# Montex Fabrics Ltd. (Extension)

04 October 2023

# Executive Summary

Figure 3.5: Roof Layout (Structural Steel)

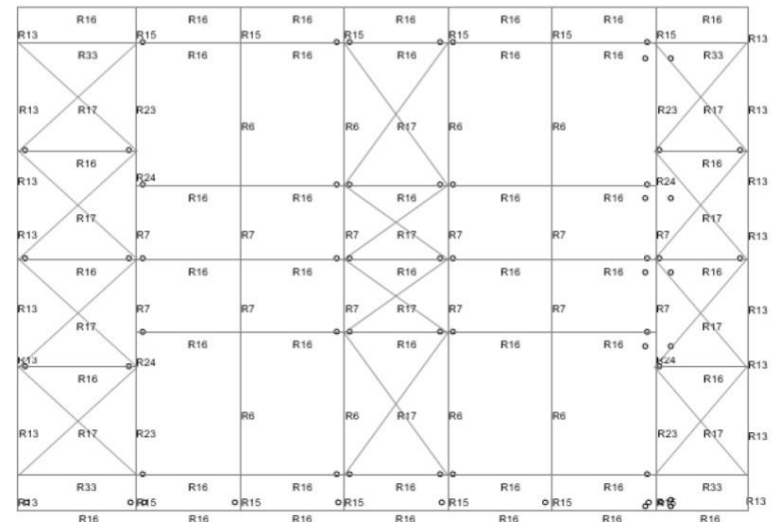
Missing compression strut member

Compression strut was found missing in several locations. So lateral stability in the long direction is incomplete. The building engineer is required to check the stability system of the existing structure and suggest remedial measures where necessary.

**Loose nut and bolt missing**

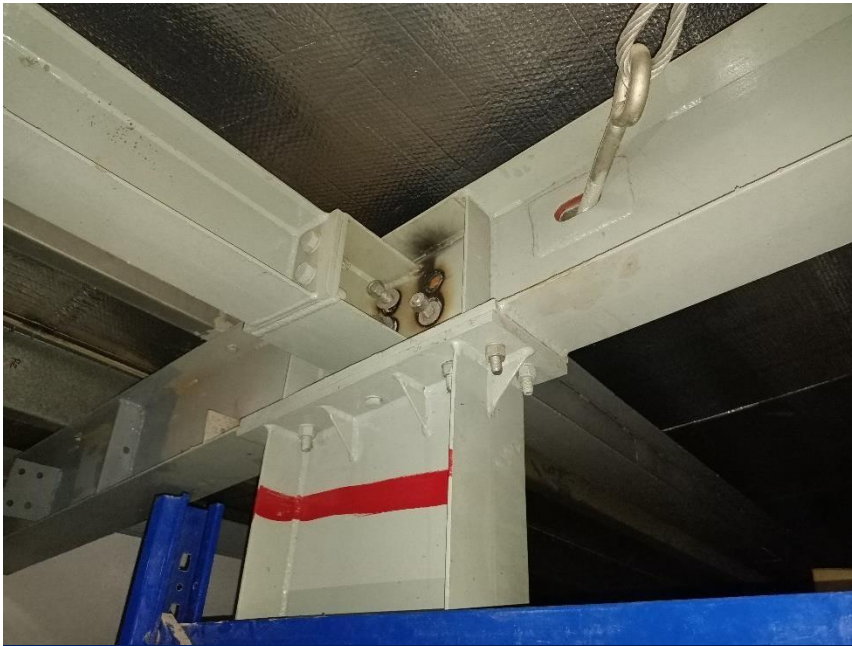
Loose nut and Bolt missing observed in joint at several locations. Building engineer is required to tighten the loose nut and install the missing bolt where necessary.

Loose nut

Bolt missing

Load plan with 42 psf (2N/m<sup>2</sup>) for first floor

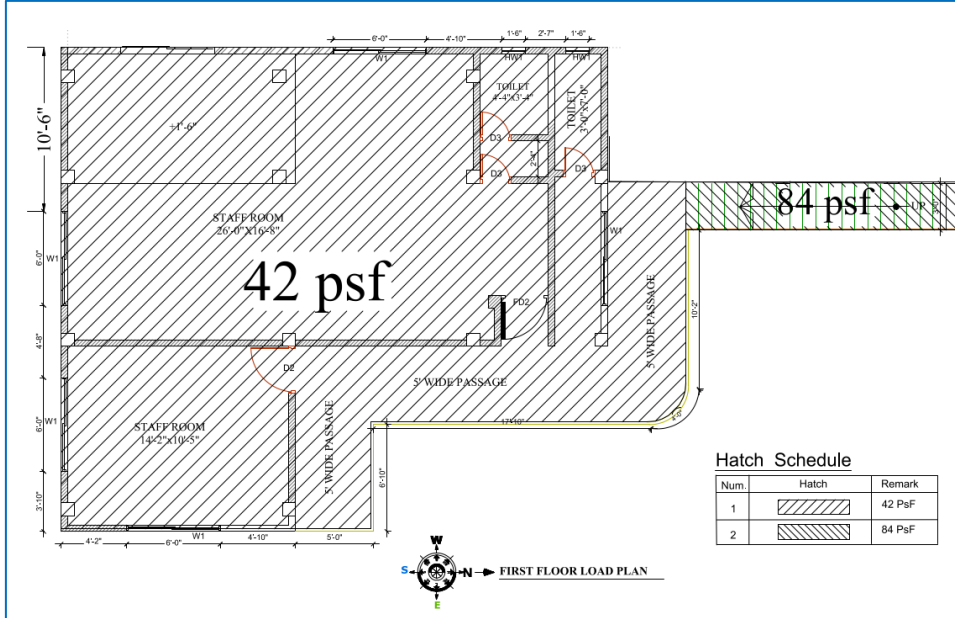
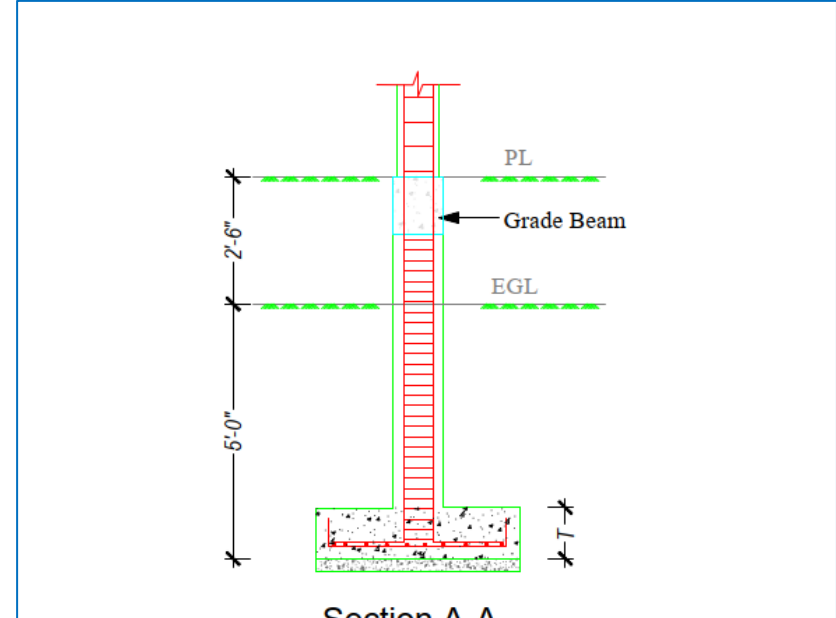
The cursory calculation indicates that internal footing stress exceeds the normal design limit considering a floor live load of 2 kPa, and soil bearing capacity of 2 ksf (FS 2.5). The building engineer is required to review the design, loads, and footing stresses.
